E5061B-20

Information Only Service Note

E5061B ENA Series Network Analyzer

The Situation – New Touch Panel & Touch Panel Controller Available

Touch Panel at the Top: Gunze, Touch Panel at the bottom: Dawar

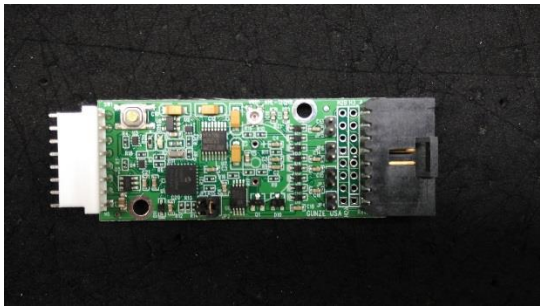
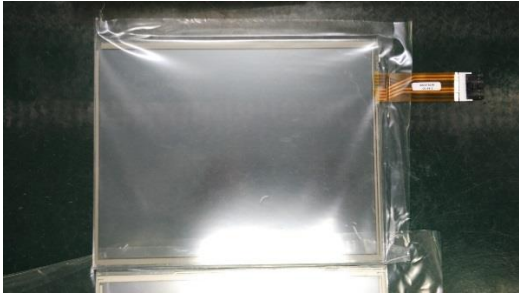
Keysight decided to change new Dawar Touch Panel & Touch Panel Controller (TPC) together with the new Firmware on E5061B. The previous generation of Touch Panel & Touch Panel Controller, SSD and so on will still be available for support.

4. Difference between Gunze/Dawar Touch Panel & Touch Panel Controller:

- For defective Gunze TPC, please replace it with Gunze TPC.
- For defective Dawar TPC, please replace it with Dawar TPC.
- Please refer to Table 1 for the compatibility.

- For Gunze TPC (0960-2972), the replacement part number is E5061-82203.
- For Dawar TPC (0960-3063) please replace with part number E5061-82204.
- Please refer Table 2 below or Table 1 on the compatibility.
